AMENDMENT OF SOLICITATION/MODIFICATION OF CONTRACT		BPA NO.	1. CONTRACT ID CODE	PAGE 1	OF PAGES
2. AMENDMENT/MODIFICATION NO. A00006		3. EFFECTIVE DATE 10-14-2015	4. REQUISITION/PURCHASE REQ. NO. 675-16-1-3252-0001	5. PROJECT NO.(If applicable) 615-14-150	
6. ISSUED BY Department of Veterans Affairs Orlando VA Medical Center 5201 Raymond Street Orlando FL 32803		CODE	7. ADMINISTERED BY (If other than Item 6) Department of Veterans Affairs Network Contracting Activity 8 (NCO 8) Orlando VA Medical Center 5201 Raymond Street Orlando FL 32803		CODE 00675
8. NAME AND ADDRESS OF CONTRACTOR (No., street, county, State and ZIP Code) To all Offerors/Bidders			(X)	9A. AMENDMENT OF SOLICITATION NO. VA248-15-R-2022	
			X	9B. DATED (SEE ITEM 11)	
				10A. MODIFICATION OF CONTRACT/ORDER NO.	
				10B. DATED (SEE ITEM 13)	
CODE		FACILITY CODE

- 1) Provide the following new or revised specifications
 - a. 09 06 00 - Finish Schedule. Revised to correct paragraph numbers. See Attachment 1,
 - b. 09 67 23.20 - Resinous Flooring Added. See Attachment 2,
 - c. 27 15 00 - Communications Horizontal Cabling. Added. See Attachment 3,
- 2) Revise construction documents by replacing each specific drawing wit

1 TELECOM RISER DIAGRAM
N.T.S.

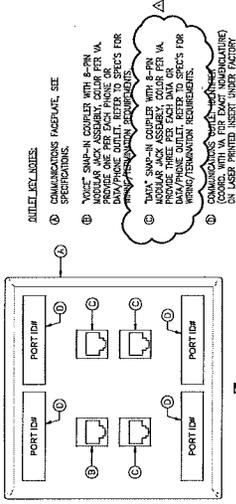
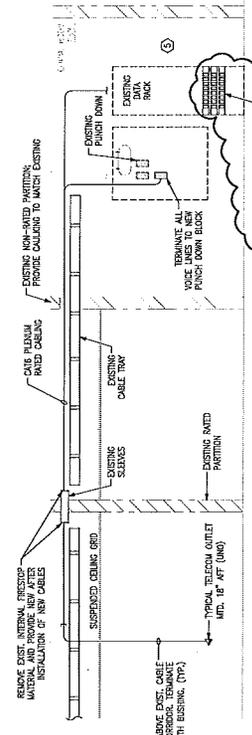
Spec call for 3 on sheet 27-15-00-15.		
Reply	See Revised drawing E500 issued with Amendment A00006 and revised Spec section 271500 issued with Amendment A00006.		
36	2. Sheet E500 Telecom Riser call for 2 24 port patch panels which is not enough ports for 2 or 3 data cables per faceplate. Does this need to be 2 48 port patch panel?	Orion	10/08/15

Reply	See Revised drawing E500 issued with Amendment A00006 and revised Spec section 271500 issued with Amendment A00006.		
37	1. Drawing PL100 & PL101: Are all hex notes describing existing conditions with no new work required?	Blue Cord	10/08/15

ACOUSTICAL CEILING CURTAIN TRACK DETAIL

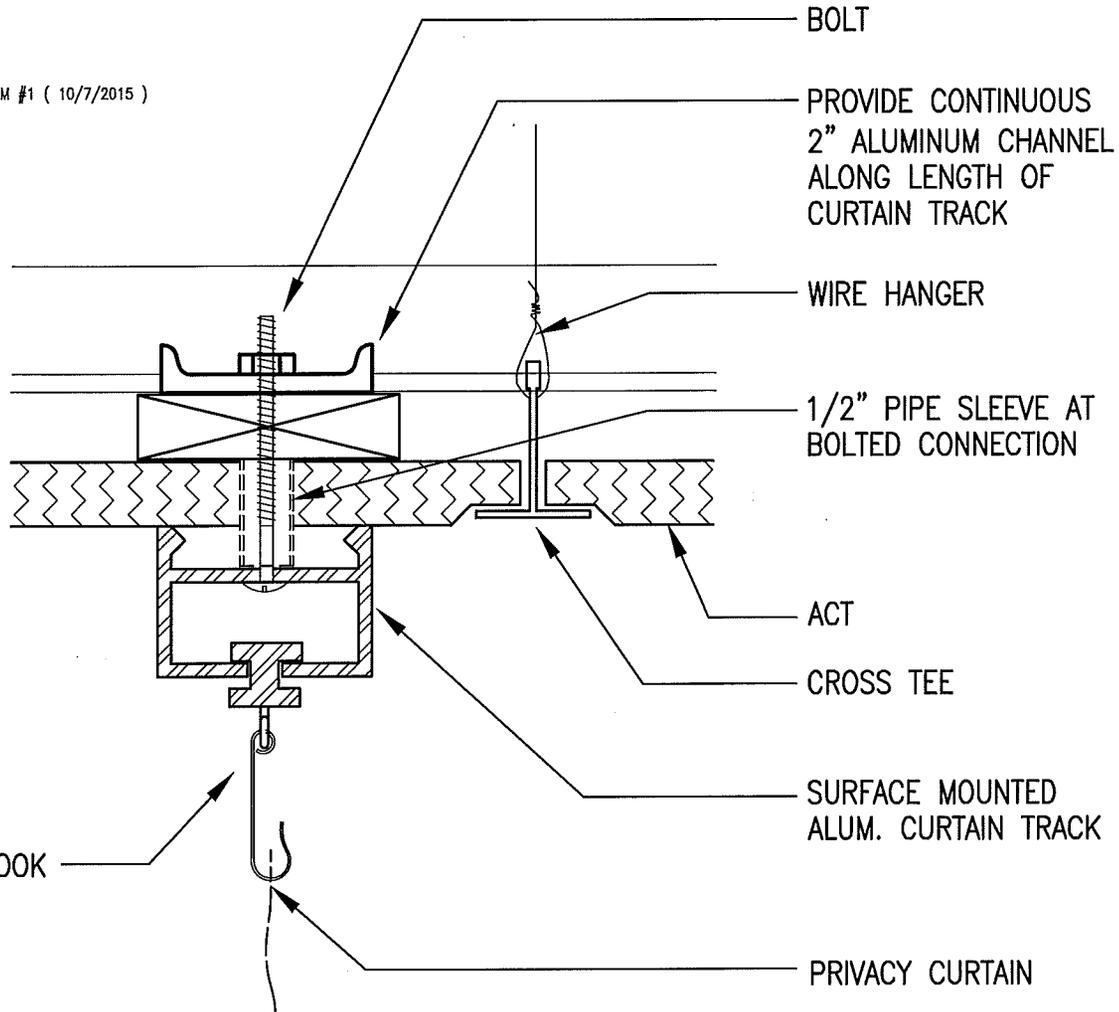
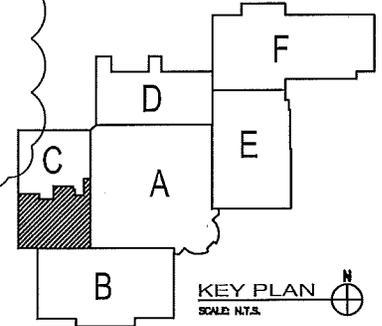
ADDENDUM #1 (10/7/2015)
